TI_2131: Component required for installation- Combi-Duo unit, left-hinged

Combi Duo E

08/11/2021

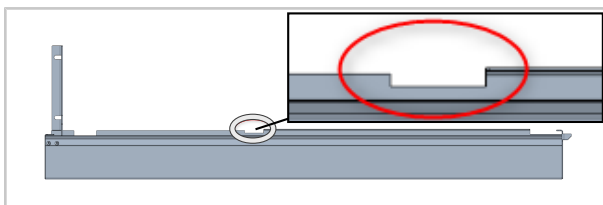
If the Combi-Duo 60.73.991 1/1 and 60.74.725 2/1 is installed in conjunction with a left-hinged unit installed at the bottom, the panel 60.75.864S for 1/1 and 60.75.867S for 2/1 must be ordered. The gaps (see graphic) for correct installation are not present for left-hinged units.

Required component for installation of a left-hinged unit.

Current component that can not be used for installing a left-hinged unit.

Component	Article number
Combi Duo E 1/1	60.75.864S
Combi Duo E 2/1	60.75.867S
